UNITED STATES
NUCLEAR REGULATORY COMMISSION
WASHINGTON, D. C. 20555

October 22, 1985

Docket No. 50-29

LICENSEE: Yankee Atomic Electric Company
FACILITY: Yankee Nuclear Power Station
SUBJECT: MEETING SUMMARY - MEETING WITH YAECo ON ECCS CODE REVISION

CORE 18 NOMINAL AND XENON POWER SHAPES FRESH FUEL AT 1000 MWD/MTU

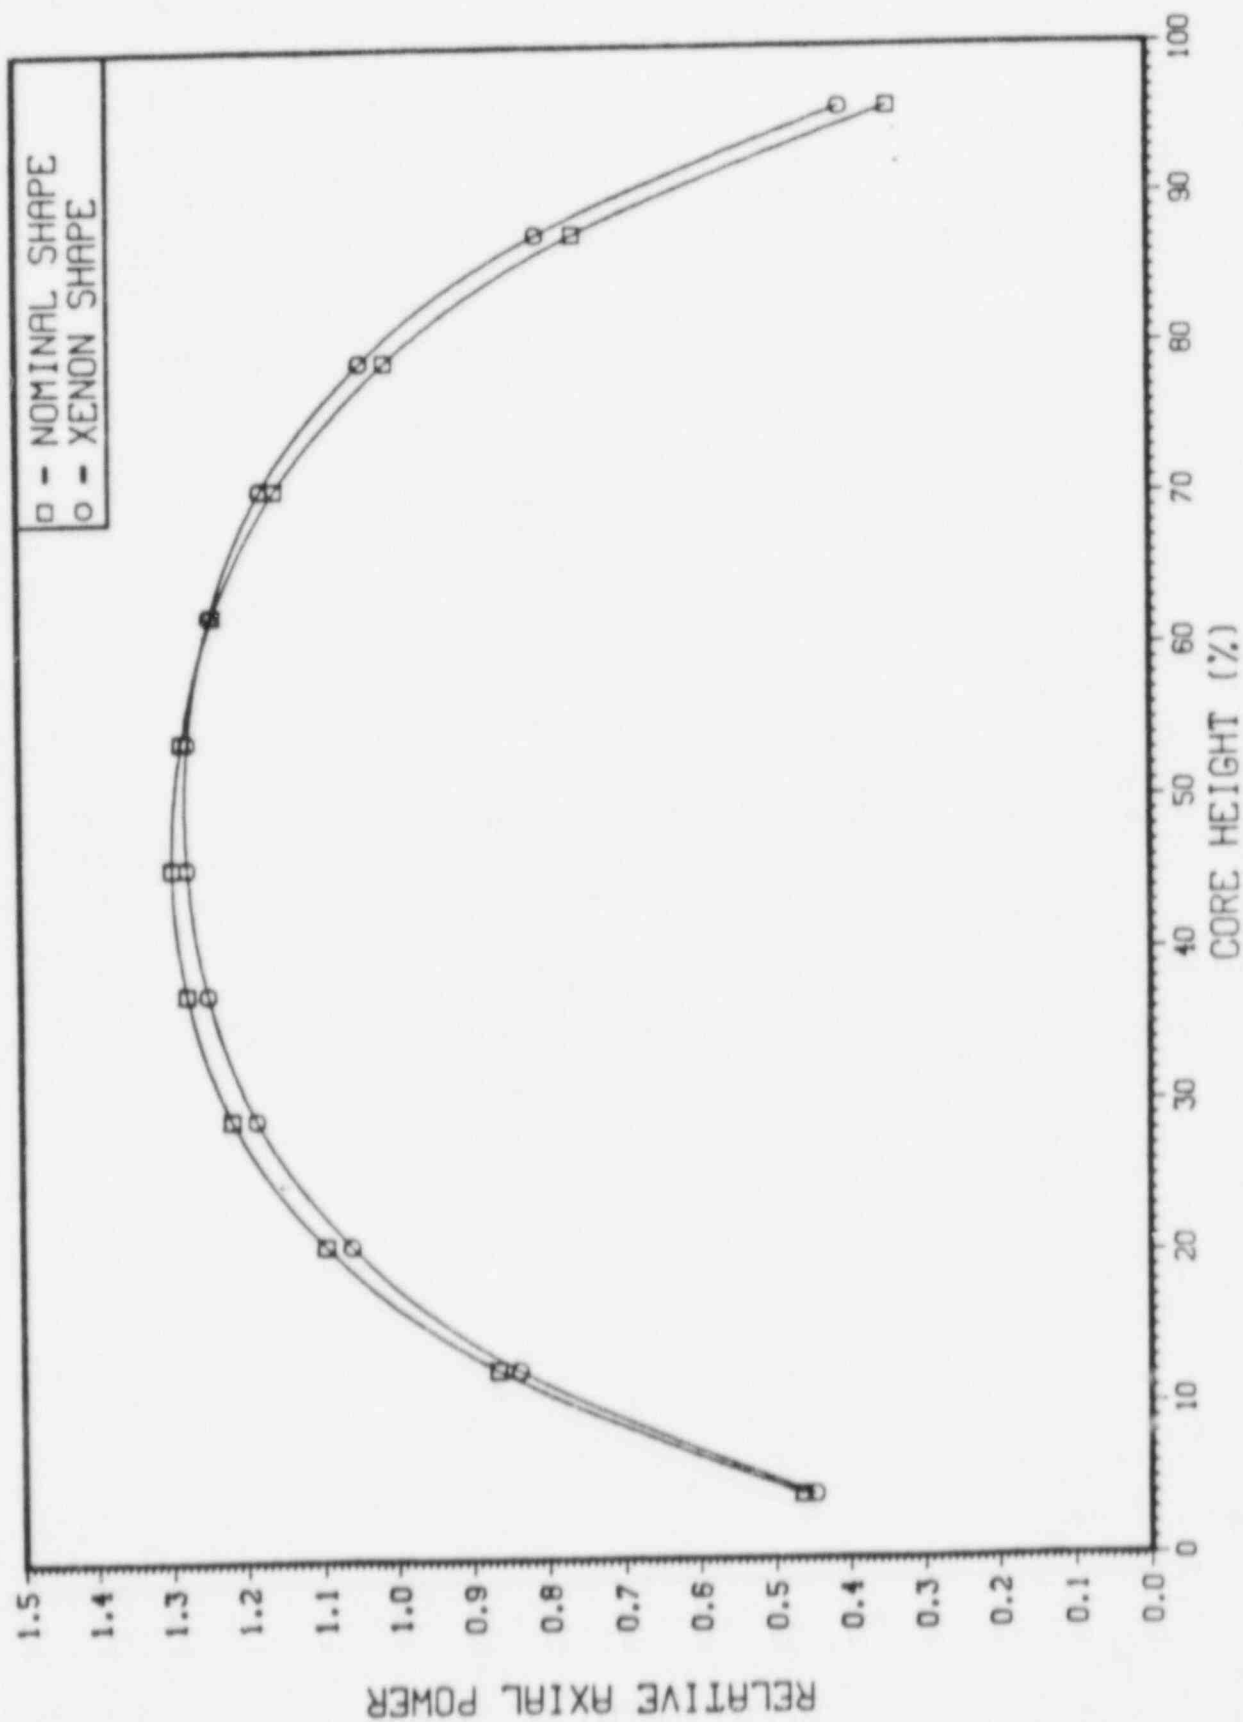
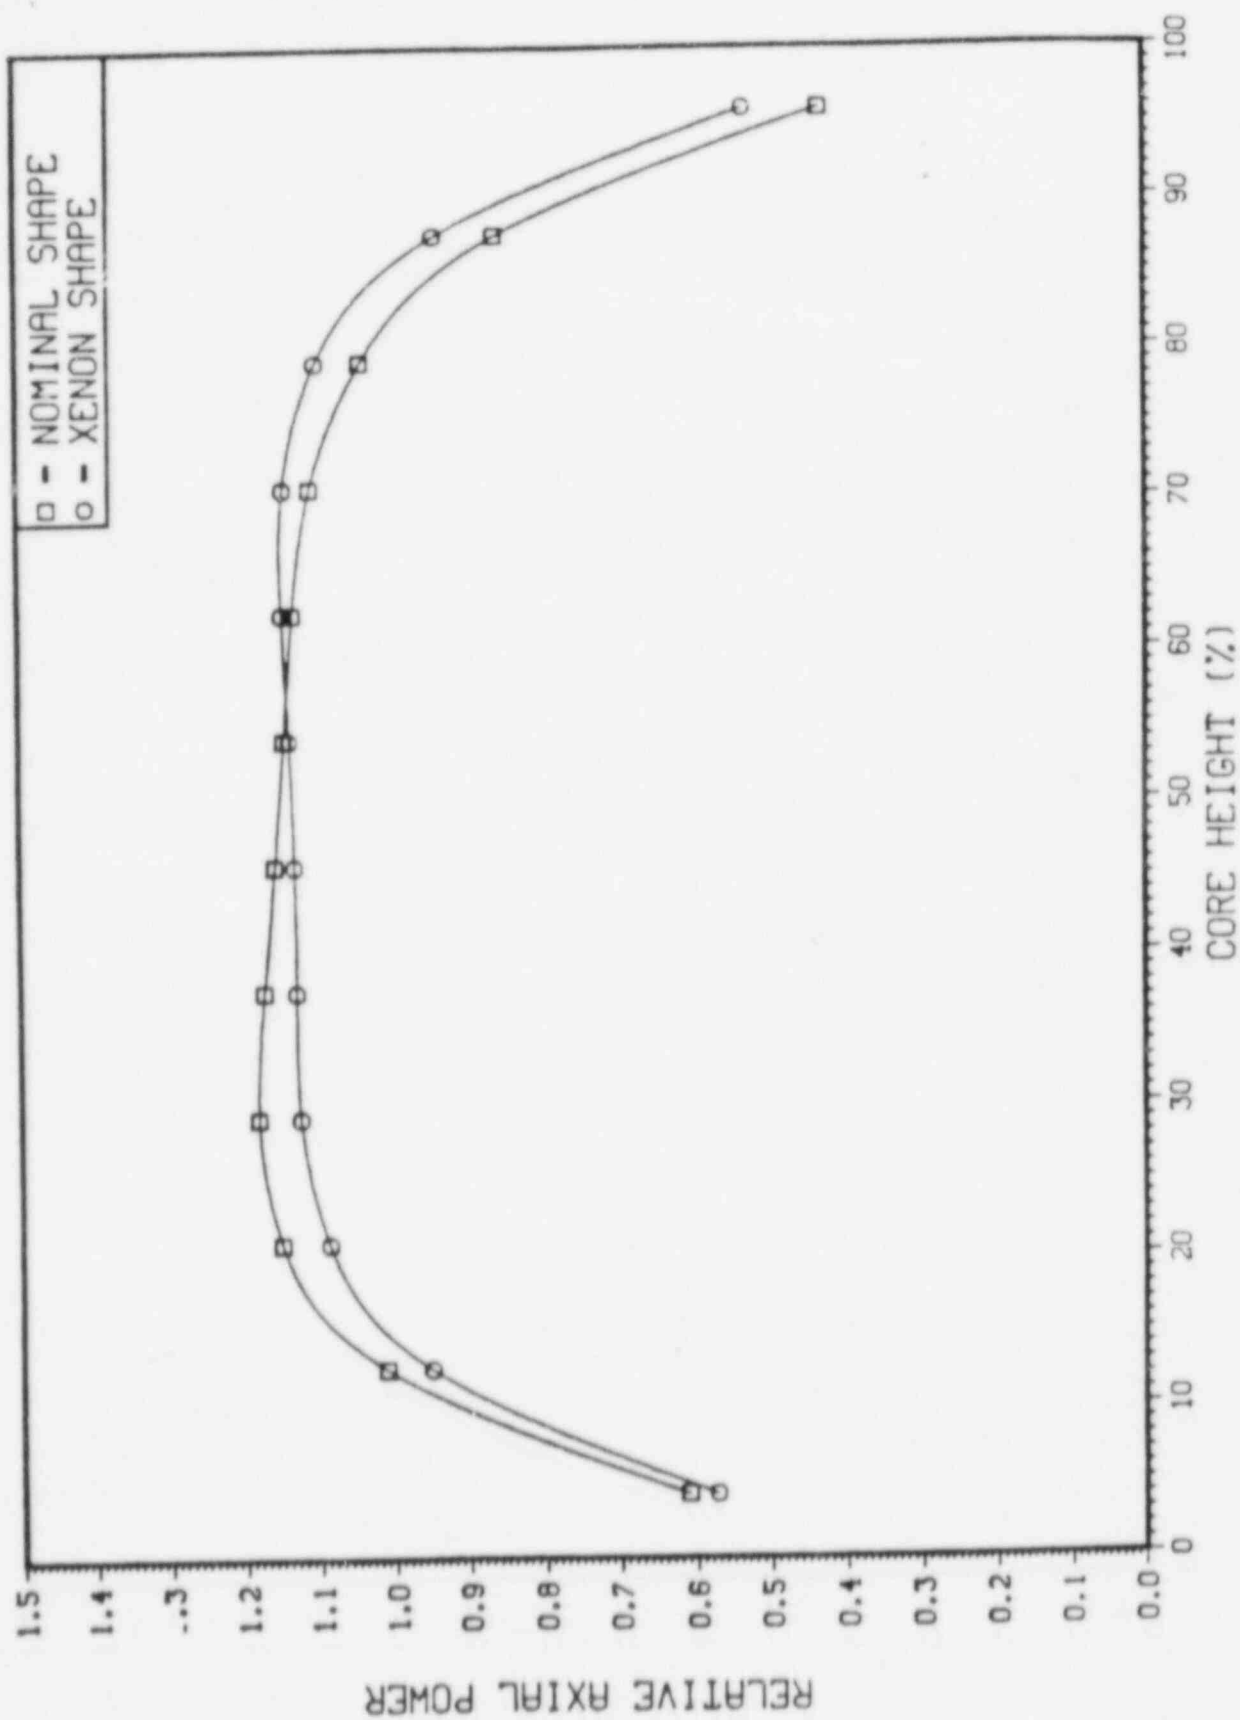
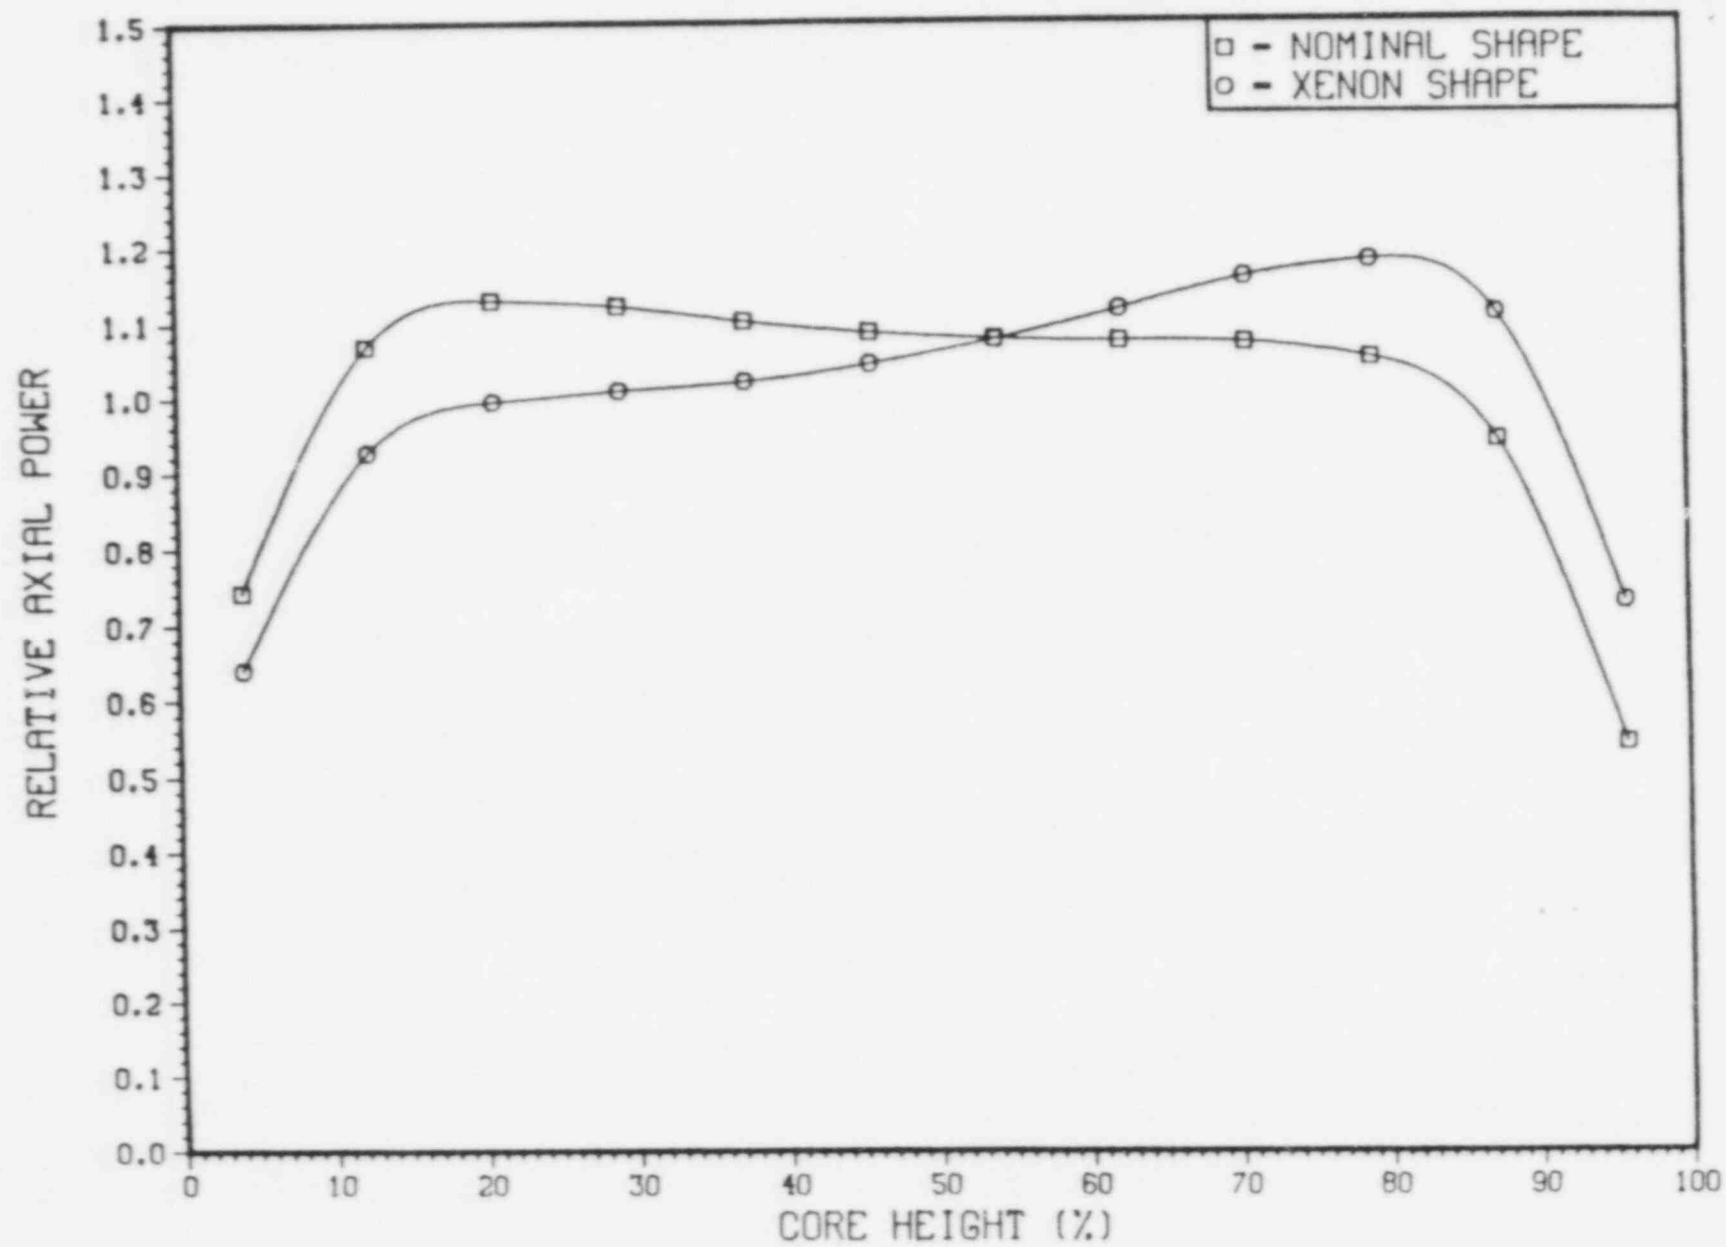
The licensee provided a discussion on the Yankee core power distributions (Enclosure 3). Following a description of the plant characteristics, the licensee described its calculated flux distributions for Cycle 18 (Enclosure 3, pages 5-8). The graphs show nominal flux distributions for various times in core life, and show the effects of xenon on the flux

distributions. As shown on page 8 of Enclosure 3, the calculated xenon transient induces a top-peaked power distribution late in core life. In response to a staff question, the licensee explained that load-following calculations for xenon transient evaluation were performed at full-power steady state conditions, with Technical Specification (TS) limits that require the plant to be held at a reduced power following a power transient to limit the effects of the xenon transients if the rods are outside the rod insertion limit shown on pages 3 and 19 of this enclosure. The licensee then described the self-damping characteristics of the xenon transient following a rod-induced power transient (Enclosure 3, pages 9 and 10).

CORE 17 COMPARISON OF AXIAL PROFILES
RESTRICTED AND UNRESTRICTED ROD MOTION
BURNED FUEL AT 10000 MWD/MTU

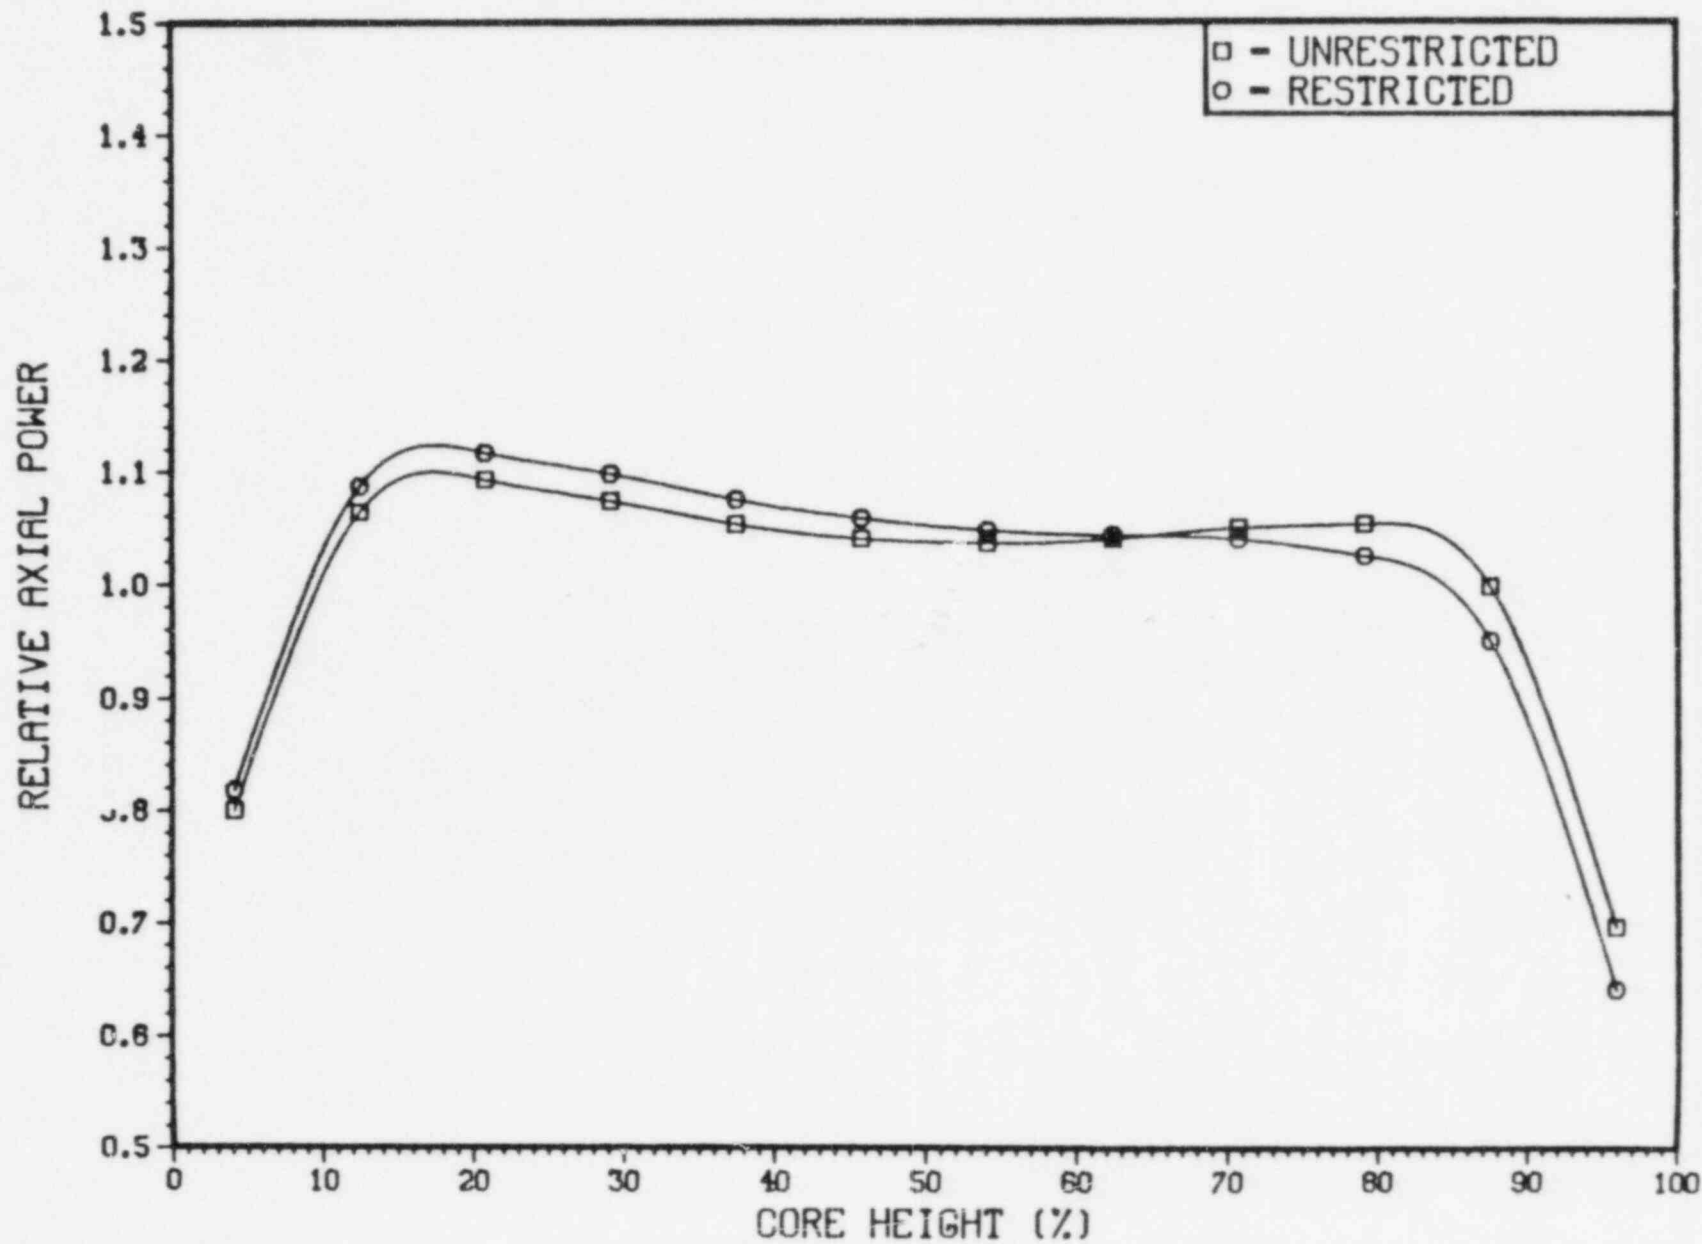
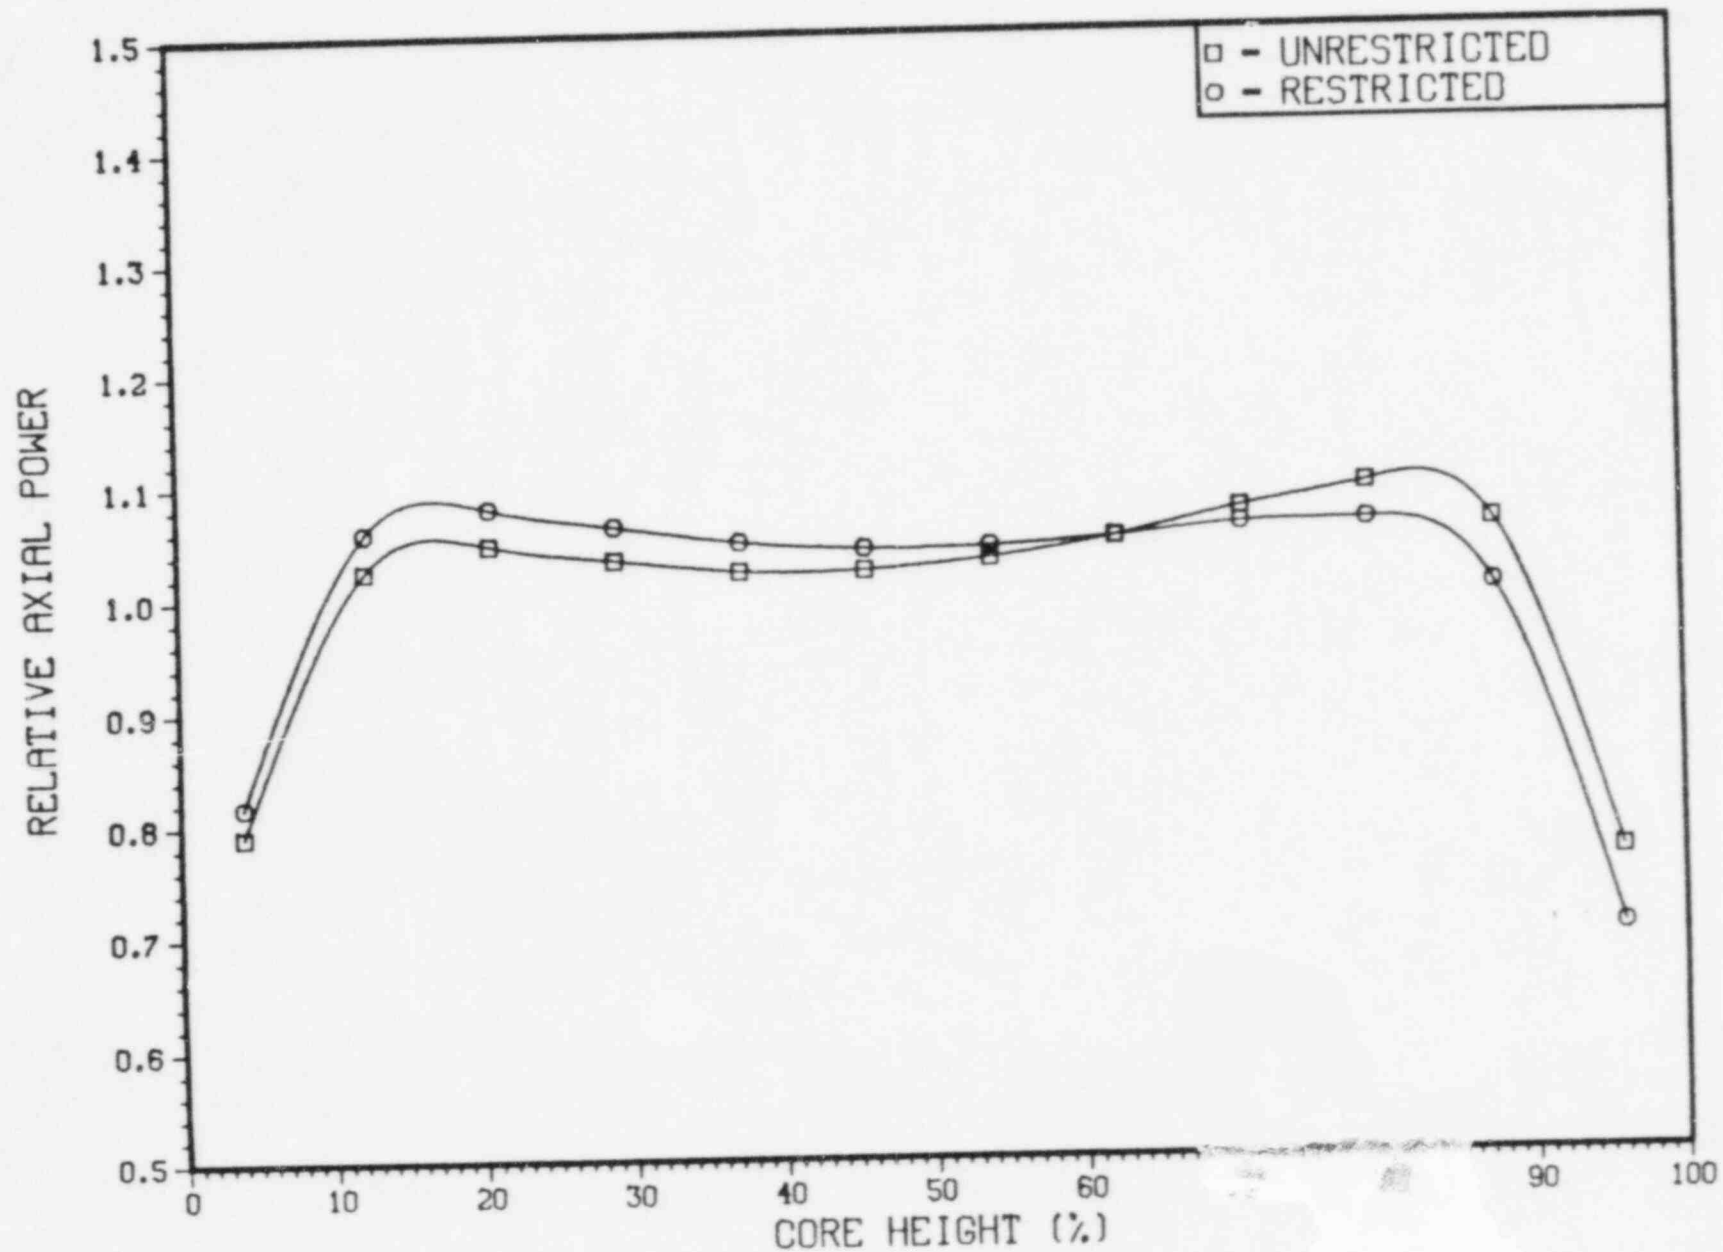
To show the effects of operating with a rodged core, graphs were provided showing the axial flux distribution with and without the rod restriction, at two times in core life (page 20, 21, Enclosure 3). Page 22 (Enclosure 3) shows the effect on xenon transients with and without the rod restriction. The graphs point out that the flux distribution is bottom-peaked with the rodged core, which has the plant within the original analysis assumptions for cycle 17 operations. The graph on page 23 (Enclosure 3) further shows the effect of reactivity rates on the axial power distribution, which points to the reason for maintaining the TS limits on reactivity rates.
